SUSQUEHANNA STEAM ELECTRIC STATION  
RESPONSE TO 6/15/95 NOTICE OF DEVIATION  
PLA-4351 FILE NOS. A17-2/R41-2

Docket Nos. 50-387  
and 50-388

# UPS 2D240 POWER SUPPLY SIMPLIFIED DRAWING

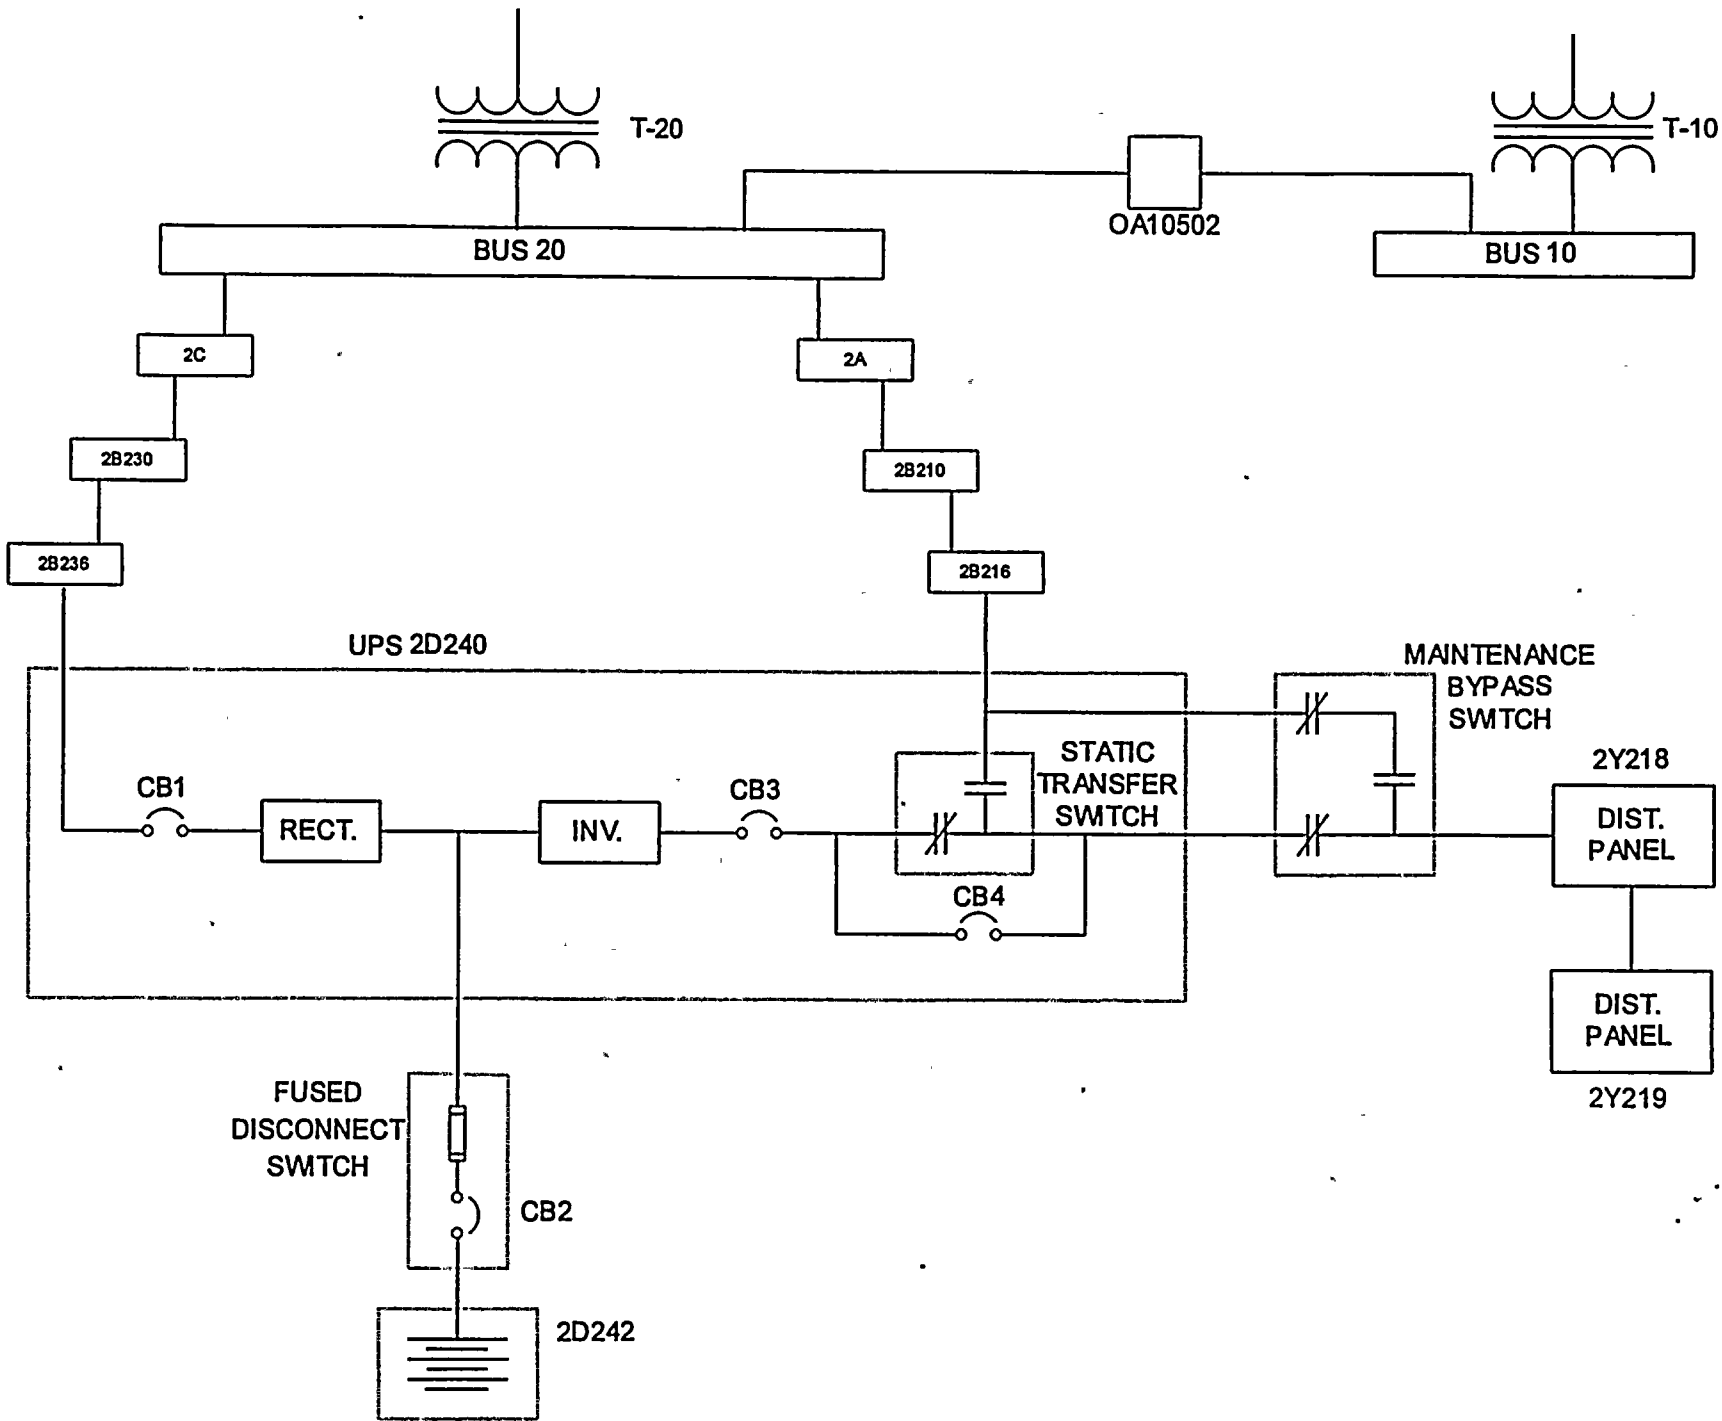
Contrary to the above, after UPS 2D240 failed a post-maintenance test on January 30, 1995, the external maintenance bypass switch was not positioned to bypass the UPS and supply the distribution panel directly from the alternate supply. The UPS was in its normal service

alignment until April 15, 1995, when it failed to provide backup battery power or a transfer (to) its alternate supply in response to an electrical perturbation.”

Our subsequent evaluation of the potential impacts on the non-vital loads aligned to the UPS in question has led us to conclude that the optimum alignment when a battery is degraded or the UPS is inoperable is for the switch to be in the bypass position.

- a. Revising the FSAR to clarify the purpose of the maintenance bypass switch, and that its position will be controlled by plant procedures.
- b. Ensuring that this commitment is properly controlled through Operations procedures. This action will also ensure that the basis for any proposed future changes to this commitment are properly documented.
- c. Training of appropriate personnel on the new procedural requirements and their basis.
